342-348 & 368-370 Victoria Street, Brunswick

Acoustic Assessment

| Project ID     | 20230312.1             |
| Document Title | Acoustic Assessment    |

Drawing Name  
LEVEL 09 PLAN

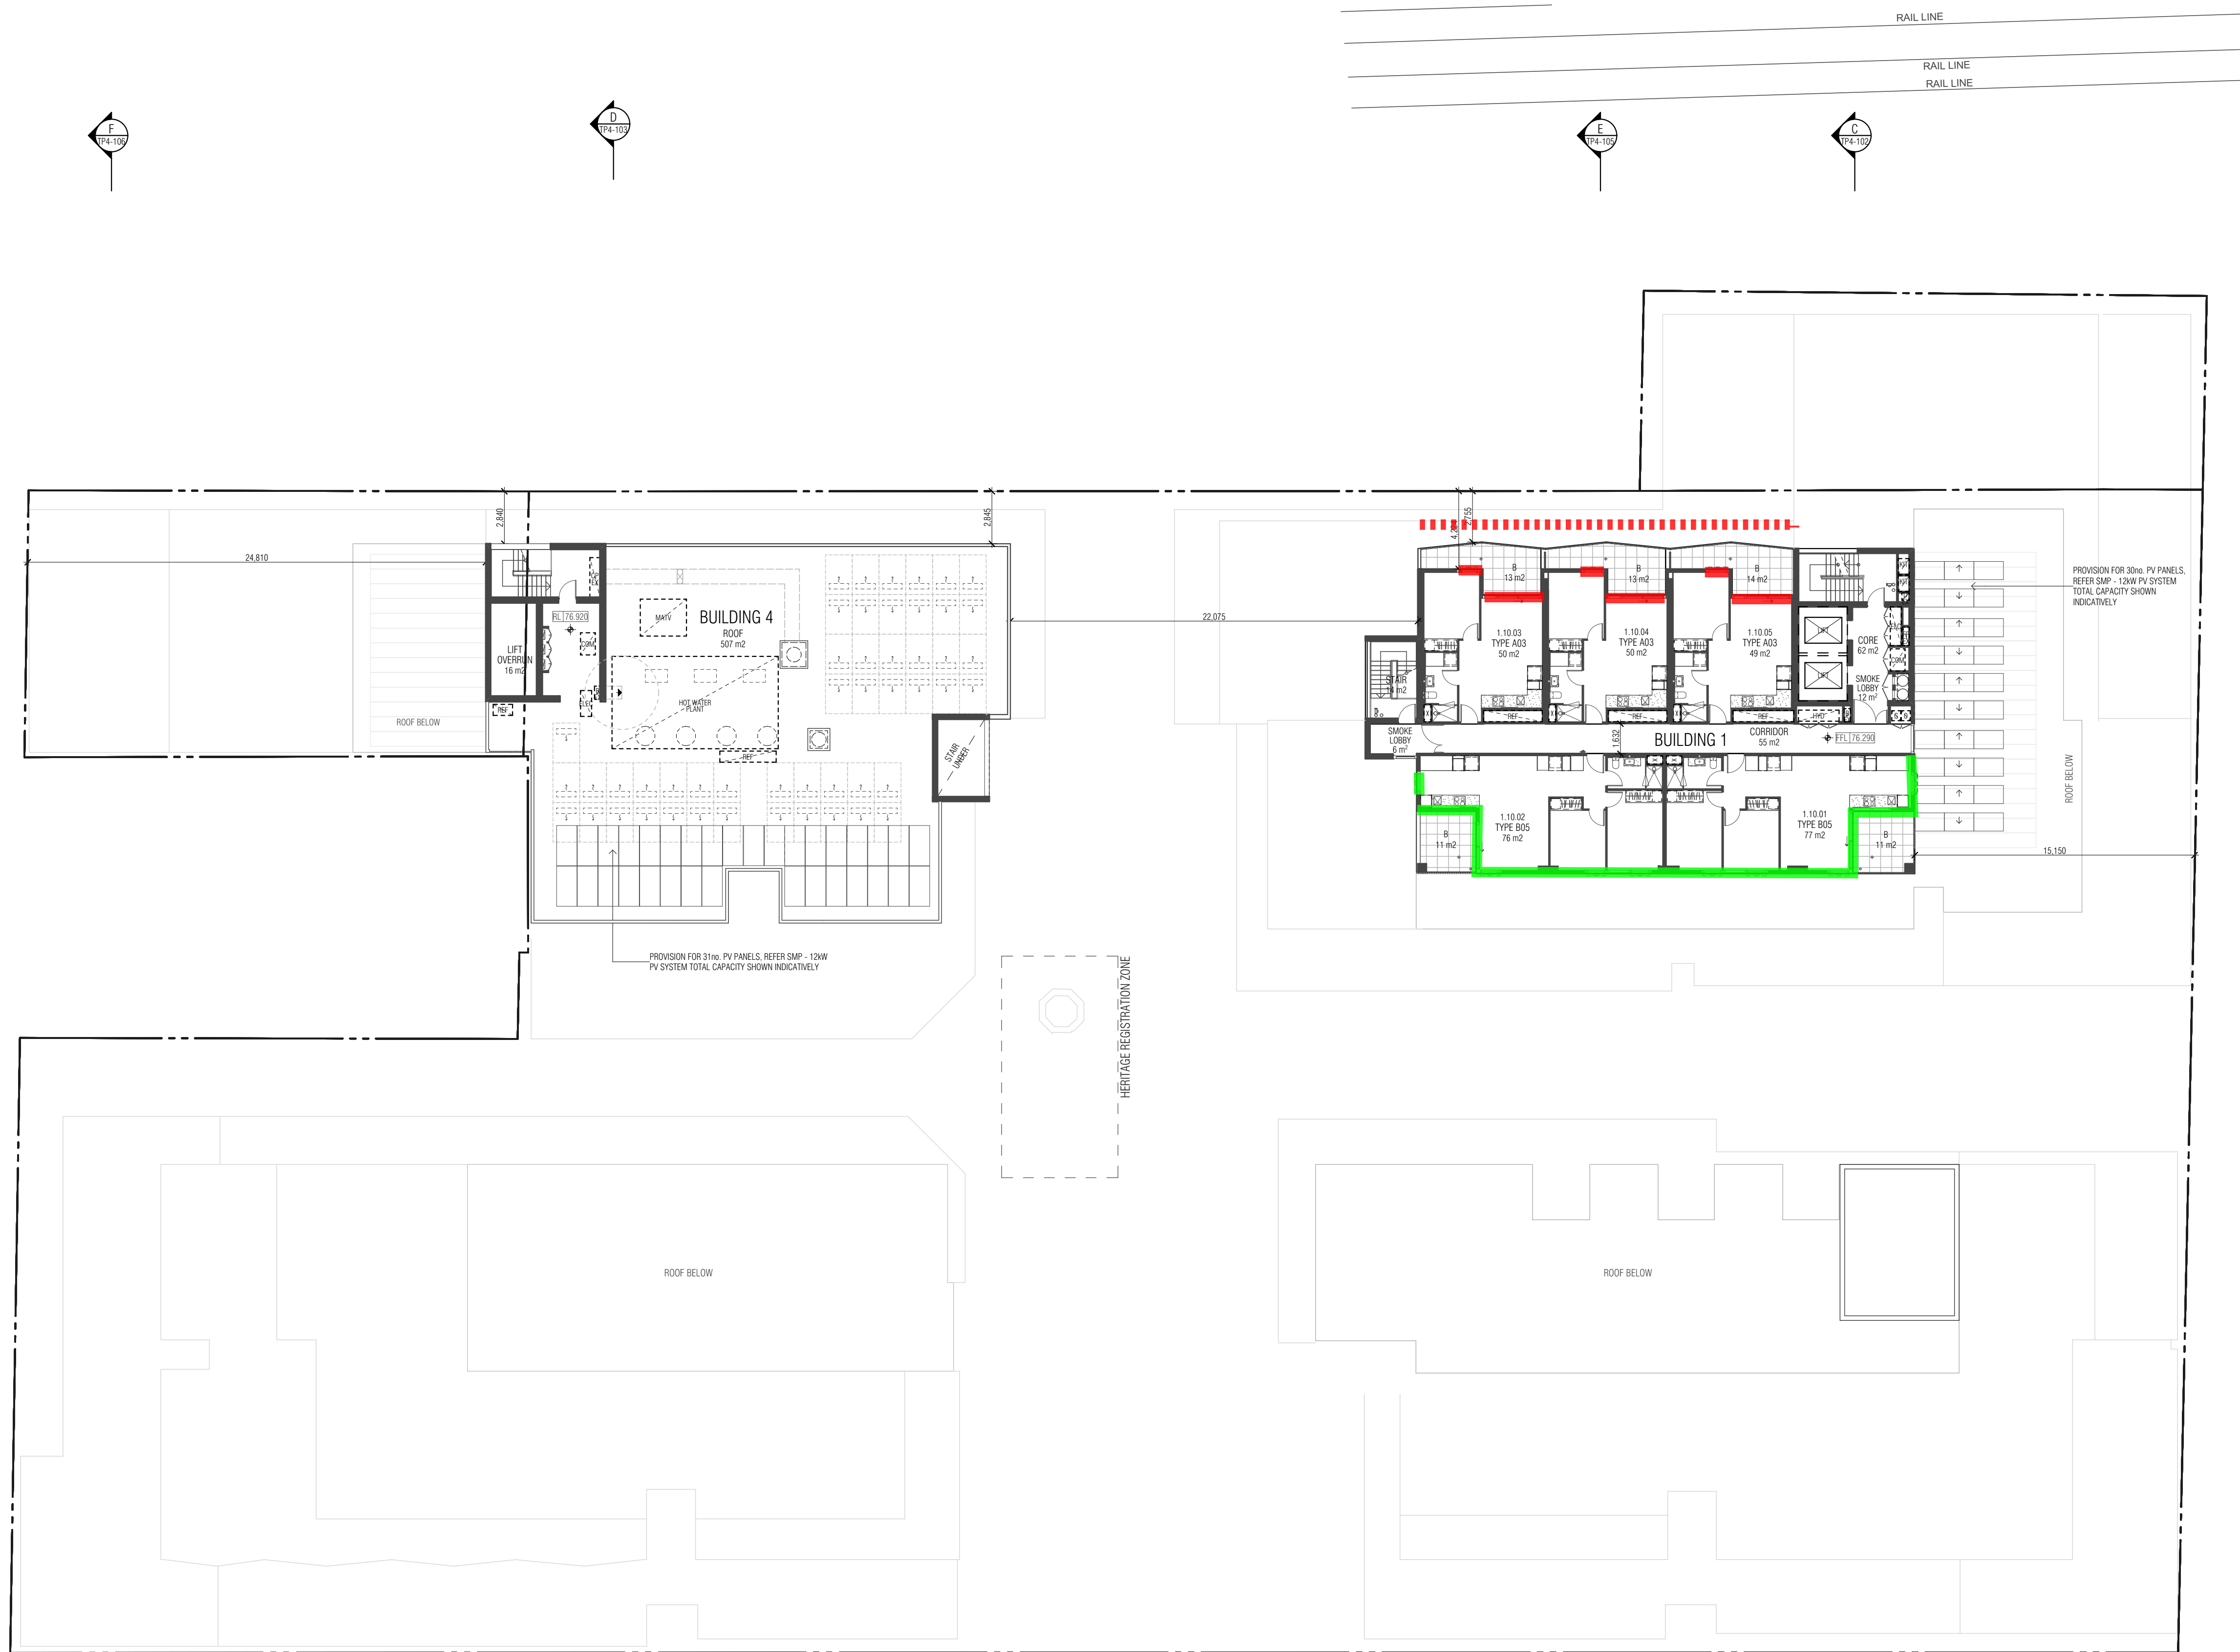
- █ Glass - 6/12/6mm IGU glass
- █ *Unmarked* Wall - 1x9mm FC sheet / 92mm stud with ins / 1x13mm pb
- █ Glass - 6/12/8mm IGU glass
- █ *Unmarked* Wall - 1x9mm FC sheet / 92mm stud with ins / 1x13mm pb
- █ Glass - 6/12/11.52mm IGU glass
- █ *Unmarked* Wall - 1x9mm FC sheet / 92mm stud with ins / 2x13mm pb
- █ Wall - 2x9mm FC sheet / 92mm stud with ins / 2x13mm pb
- █ Glass - 6/12/6mm / 150mm air gap / 11.52mm glass

Drawing Name  
LEVEL 10 PLAN

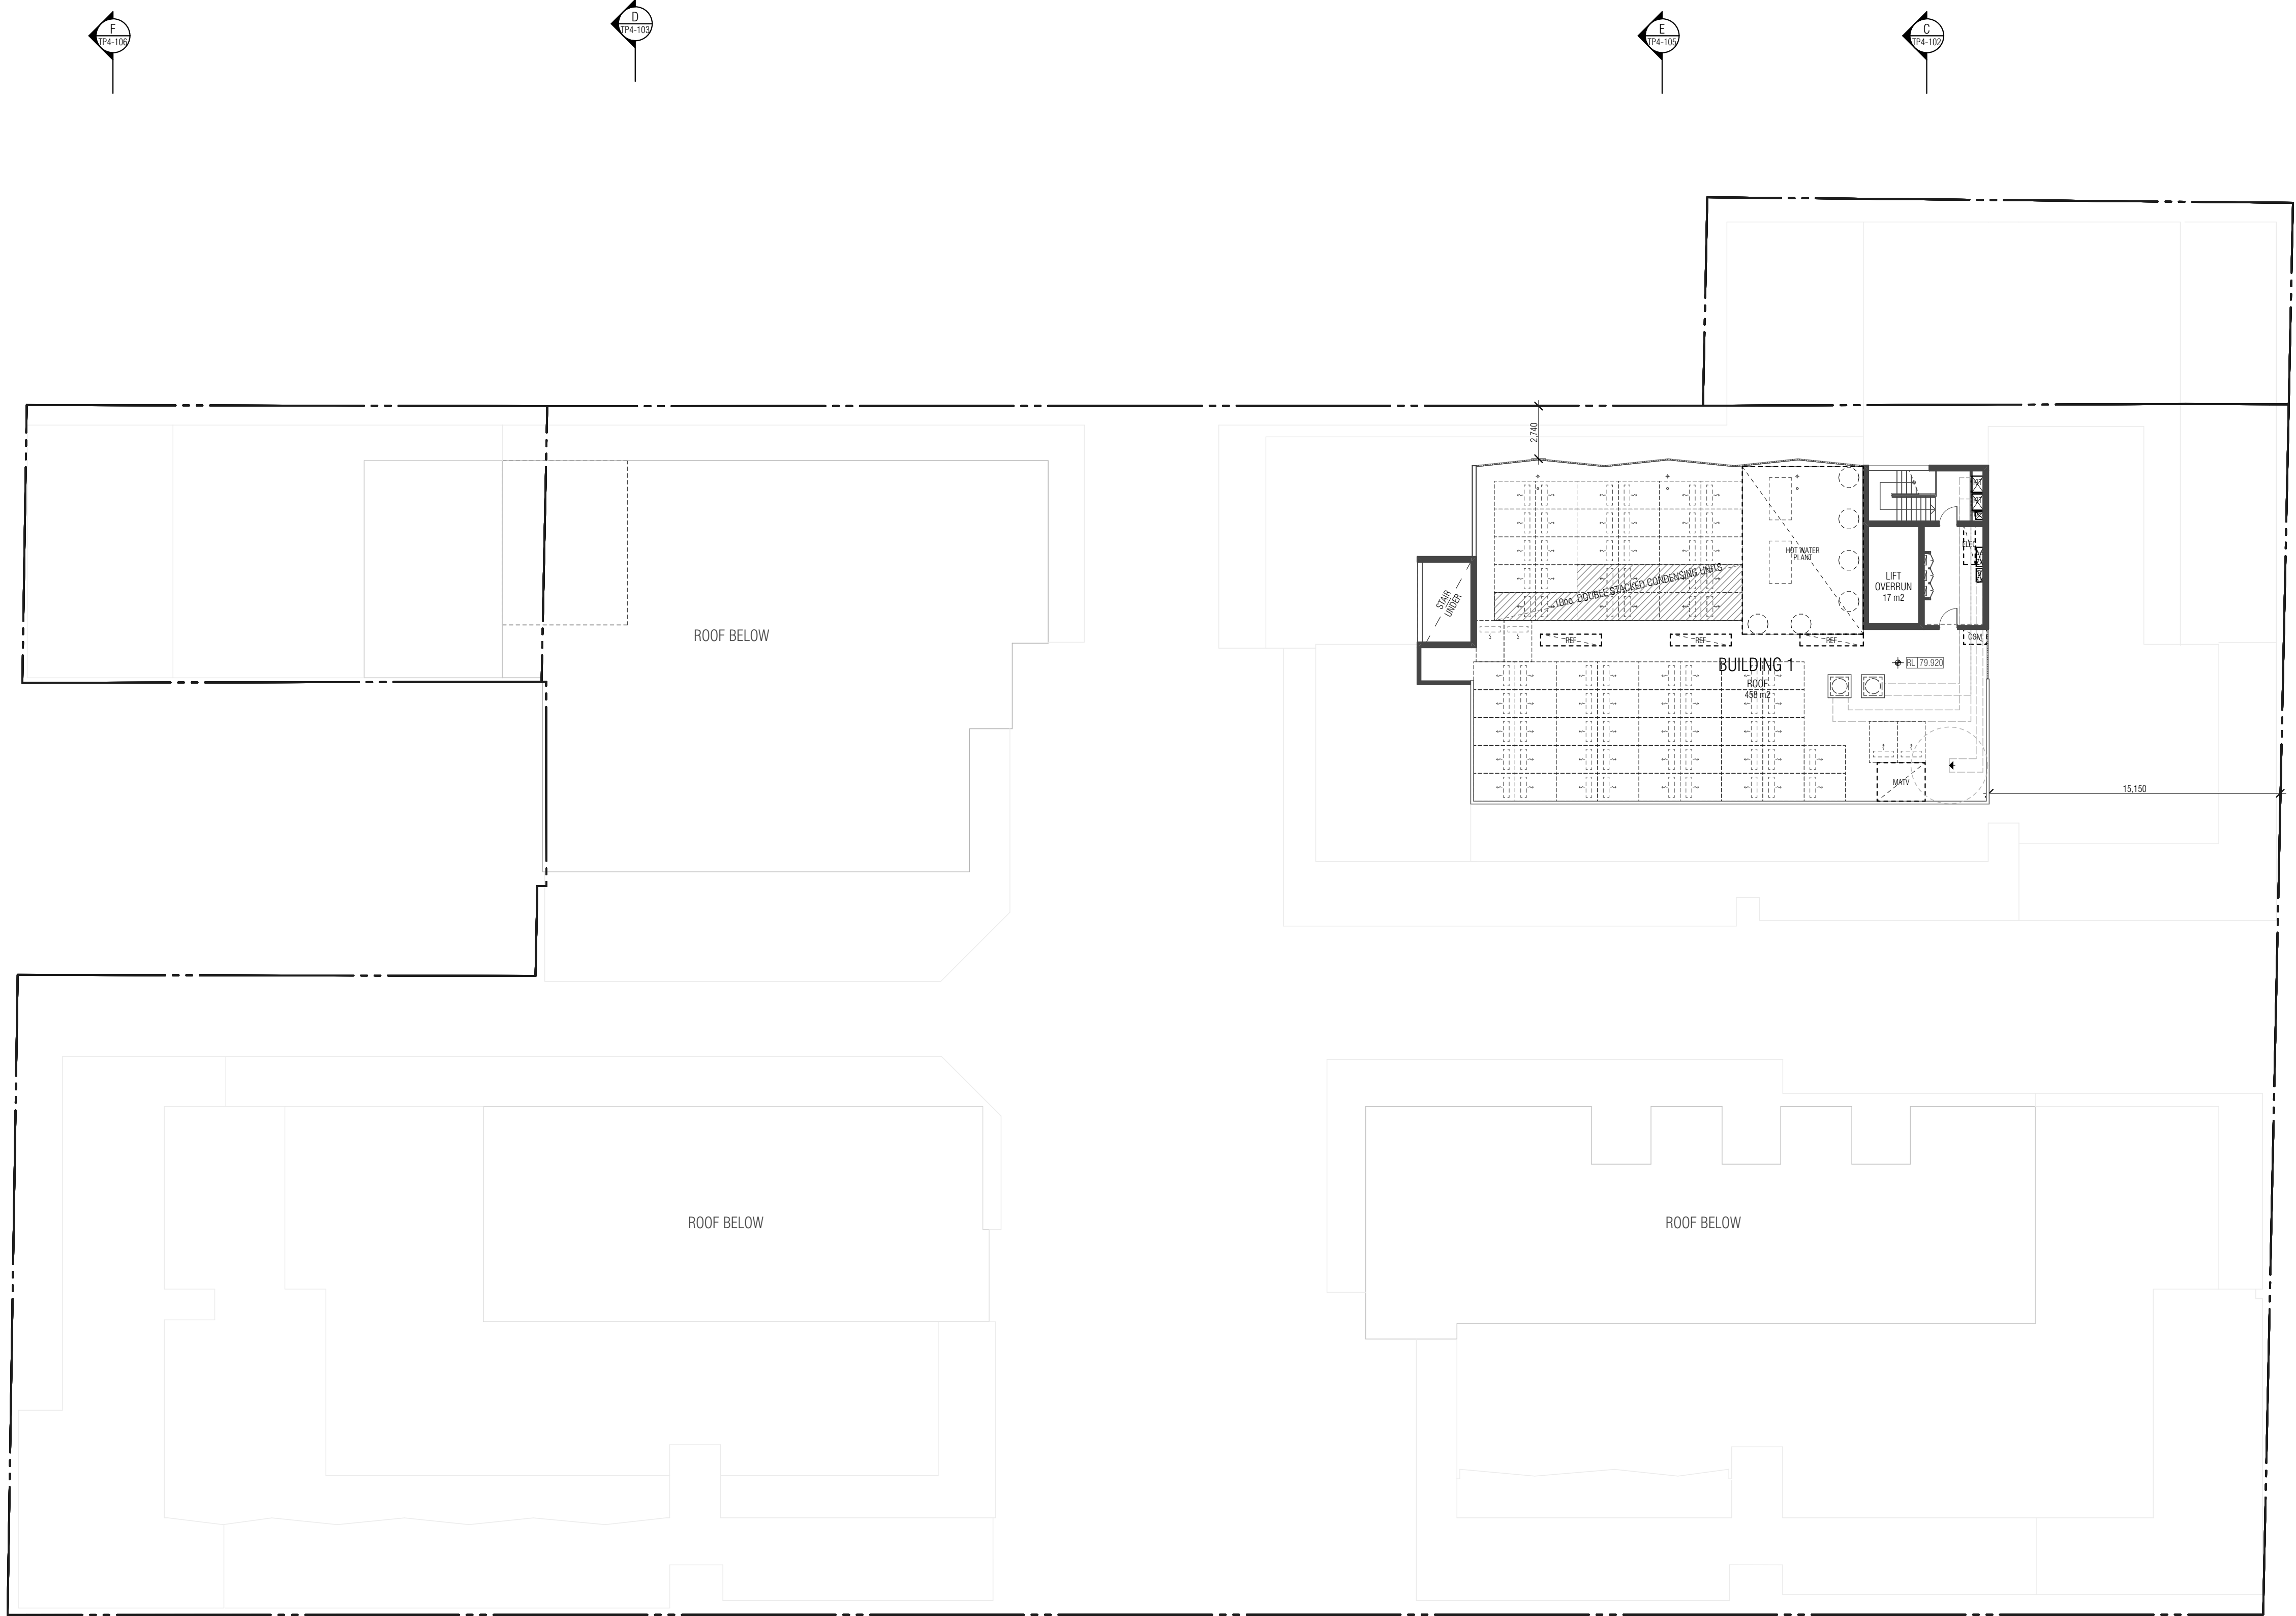
- █ Glass - 6/12/6mm IGU glass
- █ Wall - 1x9mm FC sheet / 92mm stud with ins / 1x13mm pb
- █ Glass - 6/12/8mm IGU glass
- █ Wall - 1x9mm FC sheet / 92mm stud with ins / 1x13mm pb
- █ Glass - 6/12/11.52mm IGU glass
- █ Wall - 1x9mm FC sheet / 92mm stud with ins / 2x13mm pb
- █ Wall - 2x9mm FC sheet / 92mm stud with ins / 2x13mm pb
- █ Glass - 6/12/6mm / 150mm air gap / 11.52mm glass
